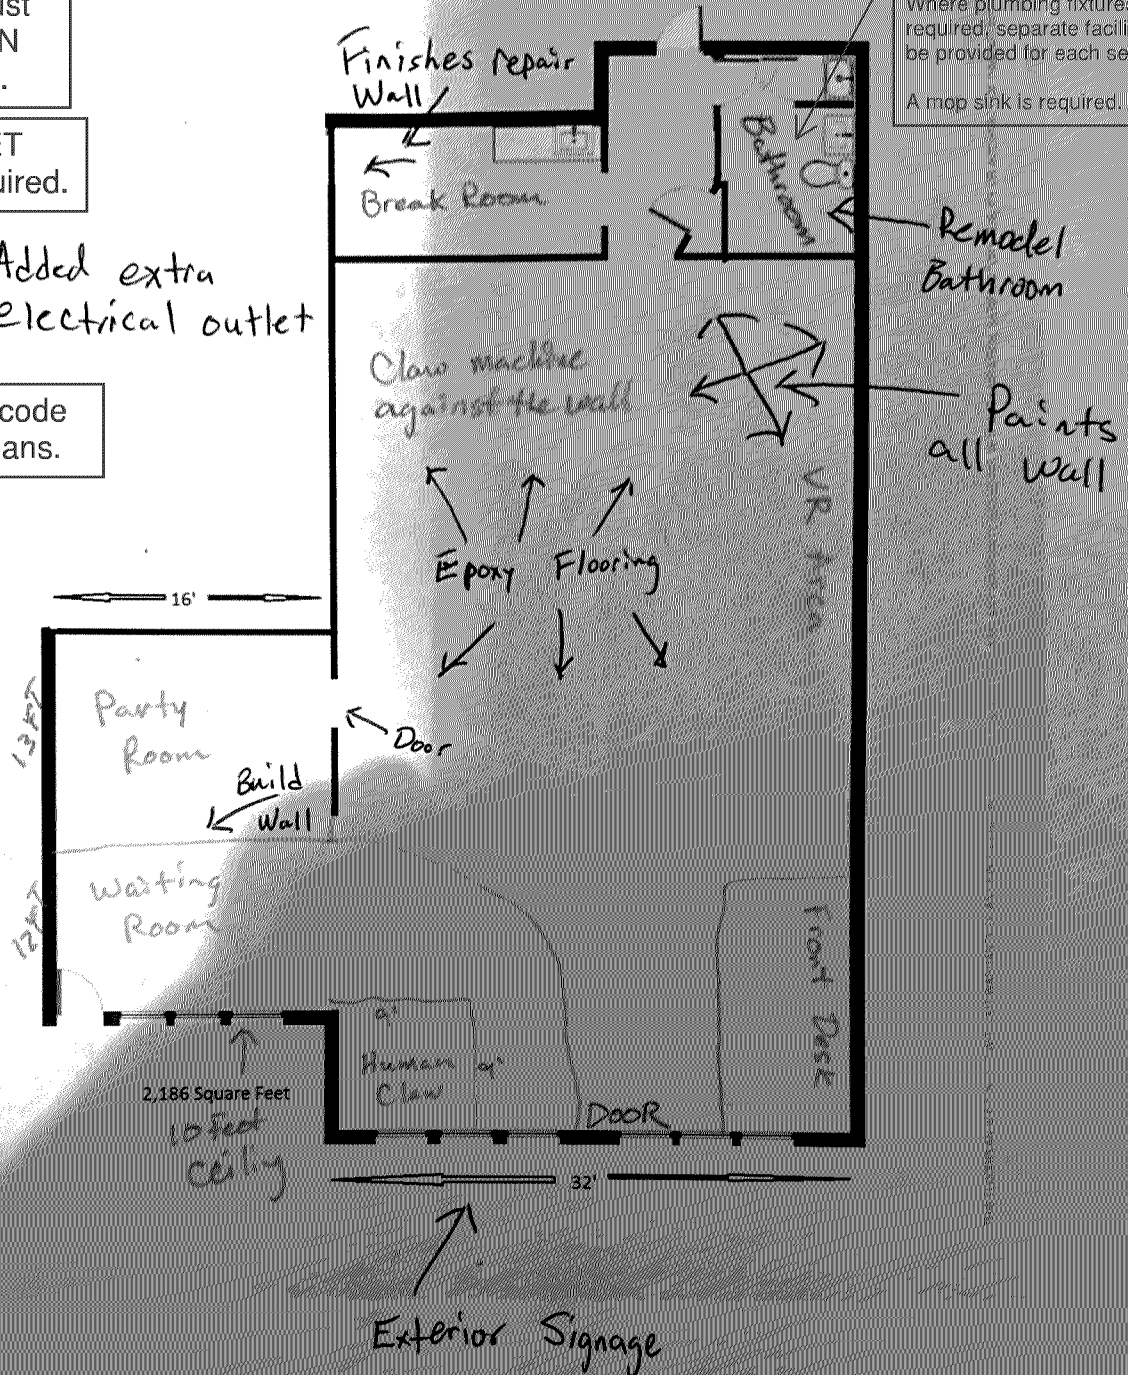
Entire space(s) shall have fully Code complying sprinkler protection.

Building/property shall be adequately signed for emergency response.

The sprinkler system may need to be upgraded in the space depending on the amount of additional plastics/combustible material.

Must meet 2020 MN  
State Building Code

Must meet 2020 MN  
Accessibility Code.

Building plans must  
be signed by a MN  
licensed architect.

SAC review by MET  
council will be required.

Plumbing fixture count shall  
meet requirements of Table  
2902.1 of 2020 MN Building  
Code. Based on number of  
occupants at least 2 restrooms  
may be required.

Where plumbing fixtures are  
required, separate facilities shall  
be provided for each sex.

A mop sink is required.

Provide a detailed code  
analysis with the plans.
